100 Chalk Farm Road
 London NW1 8EH

Proposed Elevations North & South

133 / PL17 P2

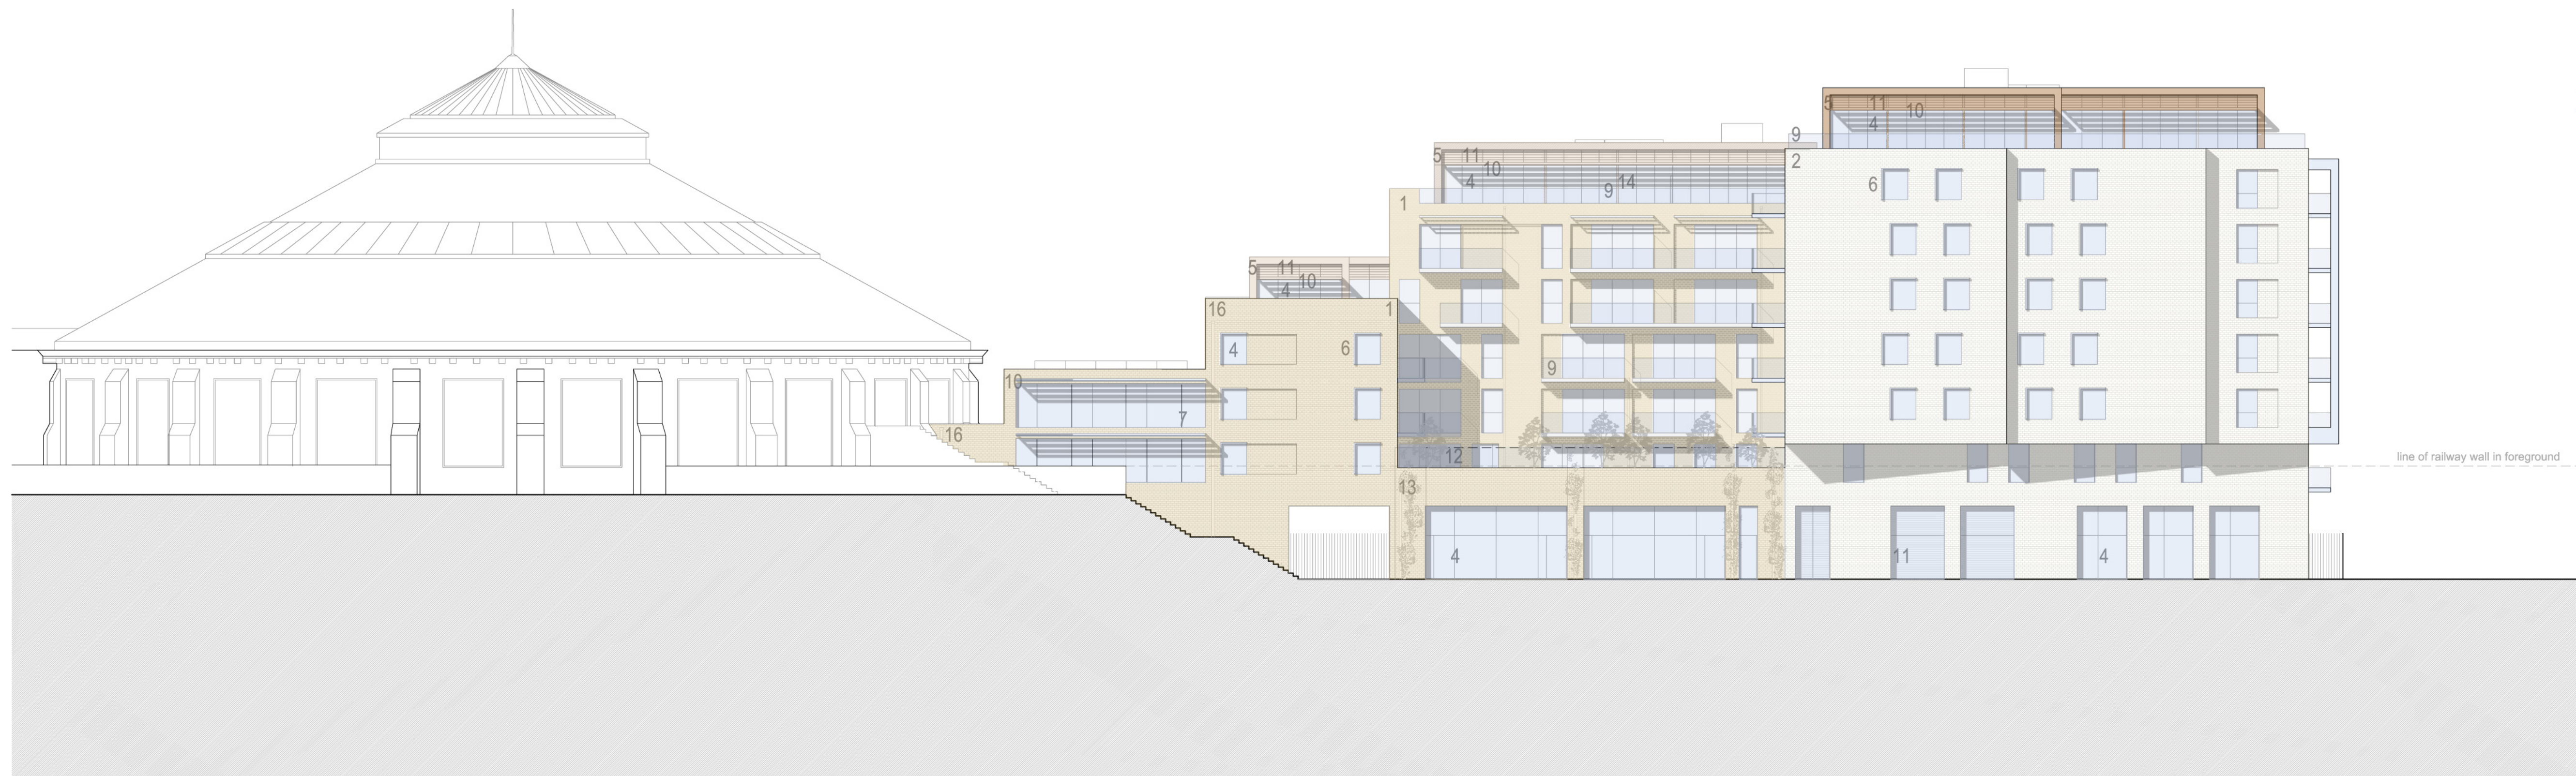
Transition building adjacent to Roundhouse reduced in height; additional brickwork detailing added to West building; Penthouses' facade treatment amended; North and East facades amended in line within flat layout changes
